Ref: 2017/218211
9 August 2017

Proposed Lindfield Learning Village, UTS site 100 Eton Road, Lindfield

Image 02: External APZs which require works

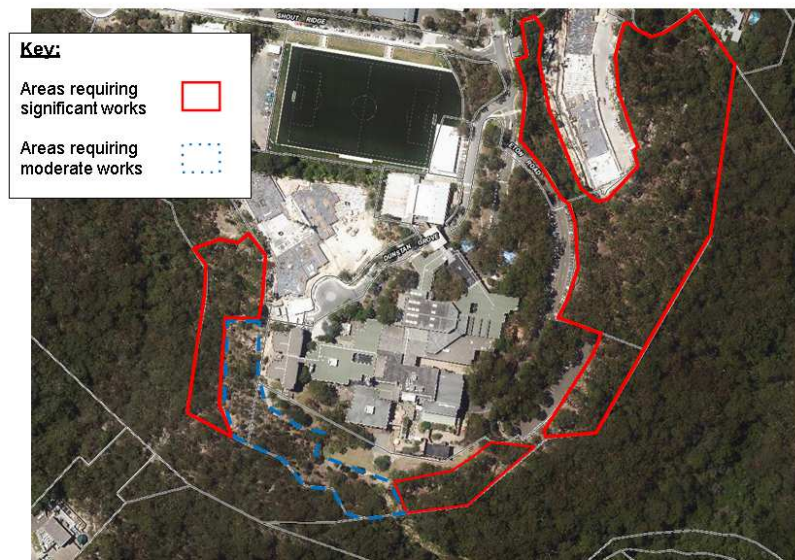
The proposal seeks to utilise Asset Protection Zones that were required as part of the ‘Edgelea Estate’ development. These areas are included in a Bushfire Management Plan but at the time of a recent site inspection (19 July 2017) significant vegetation removal / modification would be required to achieve the requirement of an Asset Protection Zone (Inner Protection Area).

The applicant does not have control of this adjoining land and does not have the ability to undertake the necessary clearing works. It is also noted that this Bushfire Management Plan is now overdue for a complete evaluation, review and update as it has been more than 5 years since it was prepared.

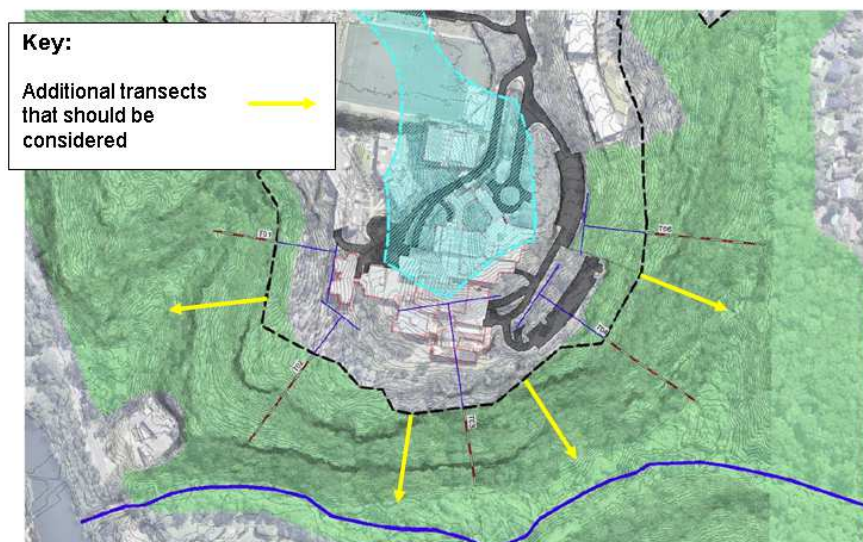
1.8 Additional transects should be included within the bushfire design modelling as steeper gradients than the transects reported were recorded on the site.

It was identified onsite and also validated in reviewing topographic mapping of the subject area (0.5m contours) that there are additional transects which are located on steeper gradients that should be considered.

The gradient is a fundamental input in the bushfire design modelling and an increase in downslope gradients results in larger flame length, higher radiant heat flux, faster rate of spread and higher fire intensity.

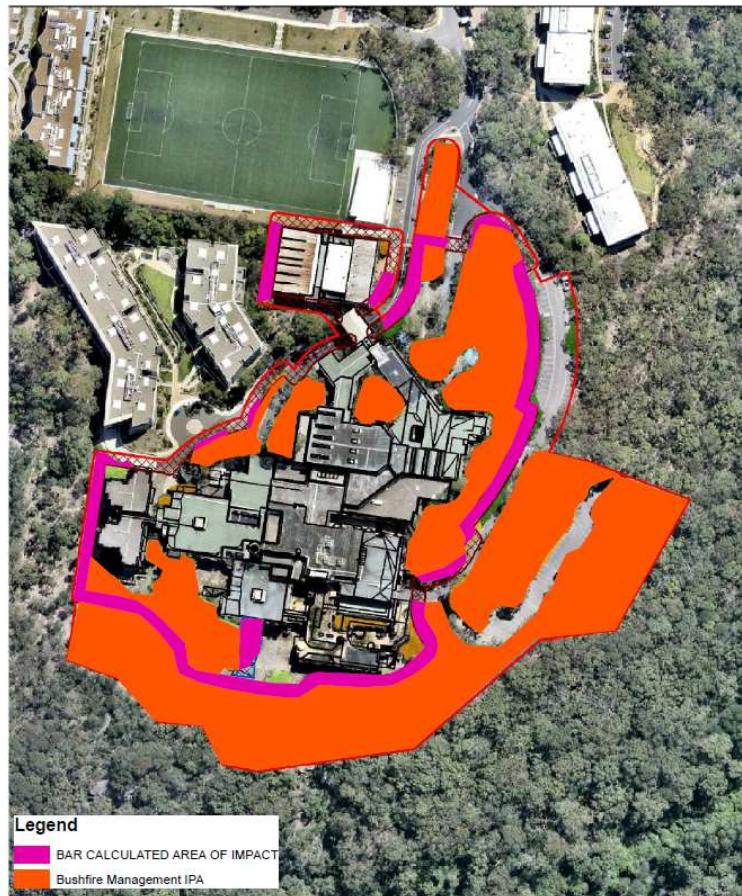
The BAR only considers the loss of the area marked as pink in the figure above and fails to consider the ecological impacts associated with the bushfire management of the site as an inner protection area (IPA). The extent of the IPA is shown in orange and is significantly greater than the pink area calculated in the BAR.

The bushfire report recommends that the site be managed as an inner protection area (IPA), it is clearly evident that the current management of the site does not meet the specifications

of an IPA and that further vegetation/tree removal is required to meet the requirements/recommendation of the bushfire report. Accordingly, the BAR should be amended to assess the loss/modification of the orange area in the figure above to that of an IPA.
